Appendix V

Comment Letters

Subject: Draft Environmental Impact Statement/Environmental Impact Report for the Crimson Solar Project

Figure W-1
Defenders/Council Alternative

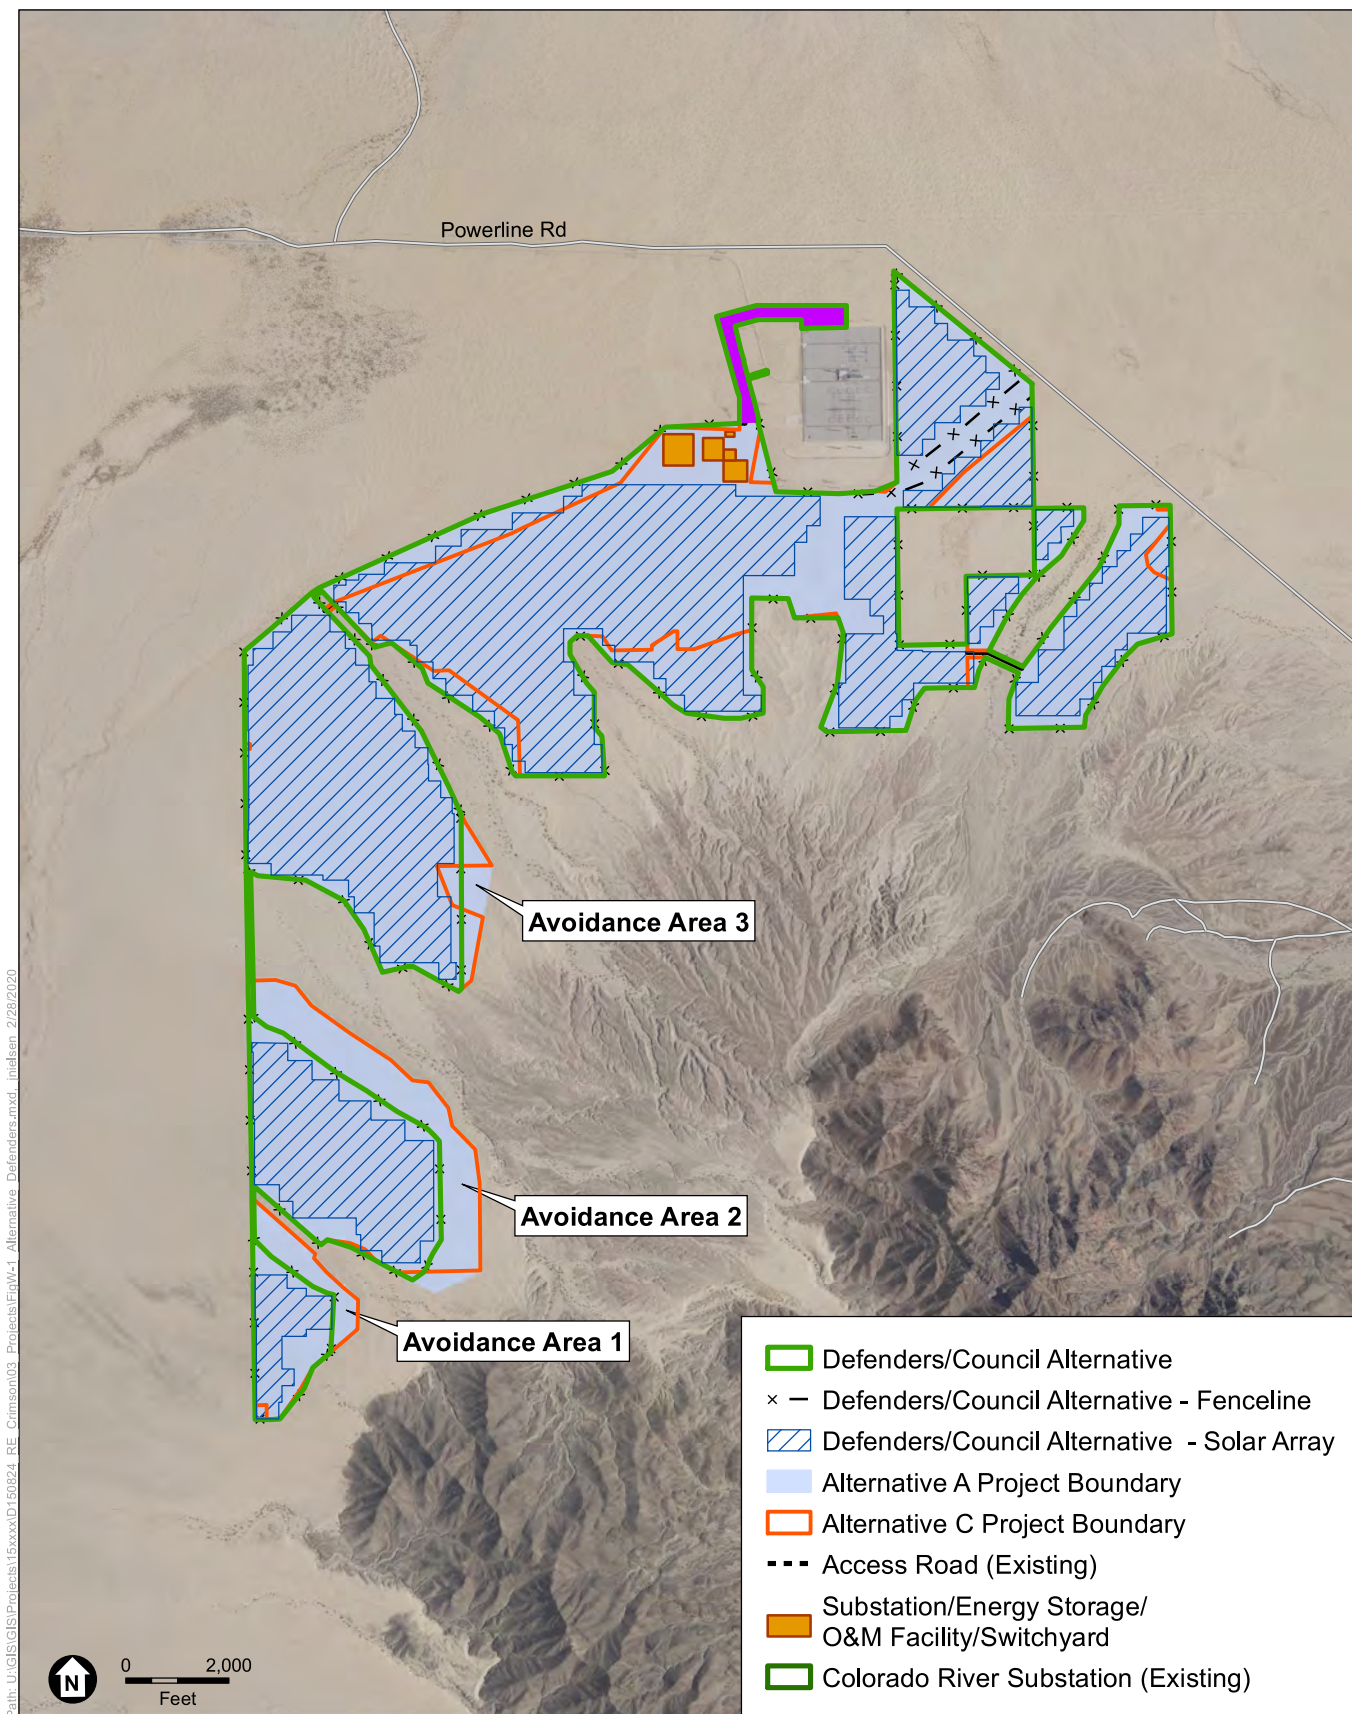
Comment: Defenders and the Council recommend an additional alternative be included and analyzed in the Final EIS/EIR for the Crimson Project that would avoid direct impacts to occupied habitat for the desert tortoise within two separate solar array fields in the southwestern portion of the Project. With slight modification, the project footprint and perimeter fence would avoid at least six desert tortoises encountered during protocol surveys, which are displayed on Figure 3.3-5, Appendix A of the DEIS/DEIR. This slight modification would exclude a relatively small amount of land from the project, not appreciably reduce electricity generation, and decrease direct impacts to the desert tortoise. A map of our recommended changes to the project footprint and perimeter fence location is included in map attached to this letter.

The map on page 5 of the comment letter depicts the locations of tortoises and occupied burrows (along with other sign) identified during 2012 and 2016 focused surveys as well as 2017 incidental findings during other surveys (see Figures 7 through 10 in Appendix I.1 for original survey results). Based on

Figure W-1, presented following responses to this comment letter, provides a comparison of the boundaries of the proposed Project (Alternative A), the Reduced Acreage Alternative (Alternative C),¹ and the Defenders/Council Alternative. The available area for developing solar arrays within the Defenders/Council Alternative boundary would be 1,709 acres, compared with 1,859 acres under Alternative A and 1,684 acres under Alternative C (Draft EIS/EIR/PA Table 2-4, page 2-17). Therefore, the Lead Agencies acknowledge the comment’s assertion that this alternative would “not appreciably reduce electricity generation” and agree that this alternative likely is both technically and economically feasible. The Lead Agencies have already expressed a preference for the reduction in area under Alternative C to avoid key areas containing sensitive vegetation, sand dune habitat, and cultural resources; therefore, a more reasonable option for resource avoidance would be to combine the two boundaries to result in an even smaller developable area. This, too, likely would remain feasible.

this, Defenders and the Council identified three potential acreage reductions, labeled as “Avoidance Areas” on Figure W-1. As discussed in Section 3 of the Desert Tortoise Translocation Plan (DTTP, see Appendix I.12), a study began in fall 2018 to number and track up to 50 desert tortoises in the Chuckwalla Valley for 18 months through spring 2020 using radio transmitters attached their shells. The purpose of this research was to help confirm existing densities in the Project boundary and adjacent habitat, provide movement data and activity areas, health status, inform the translocation process, and provide additional habitat data” and “may be used to determine the extent tortoises are using the Project site, increase certainty of the total number of tortoises that may be translocated, and assist in the determination of the most-appropriate recipient site.” Results of this study indicate that the relative size of tortoise home ranges varies within the study area (Ironwood 2020). Two of the transmitted tortoises’ home ranges include all or a portion Avoidance Area 1, and the relative tortoise density in avoidance area is low to moderate. Portions of seven transmitted tortoises’ home ranges intersect Avoidance Area 2, and the relative tortoise density is moderate to high within some of the avoidance area and low in much of it. Two of the transmitted tortoises’ home ranges include small portions of Avoidance Area 3, and the relative tortoise density in this avoidance area is low. Overall, nine individual tortoises were found to use a portion of one or more of the Defenders/Council Alternative Avoidance Areas, out of 37 tortoises from which data were collected. However, the portions of the Avoidance Areas used by six of these nine tortoises did not make up substantial portions of those tortoises’ home ranges. One other small area of the Project site was used by five tortoises. Most of the Project site showed no occupancy by transmitted desert tortoises, while tortoise density in the area between the Project site and the Mule Mountains was high. The tortoises that did use the Avoidance Areas also spent time in these higher-density areas outside the Project site.

Because the Project already has been refined, and mitigation measures imposed, to minimize impacts on desert tortoise, the Lead Agencies do not find that the Defenders/Council Alternative would substantially reduce significant impacts compared to the proposed Project. Therefore, this alternative has not been carried forward for detailed consideration in the Final EIS and Proposed PA.
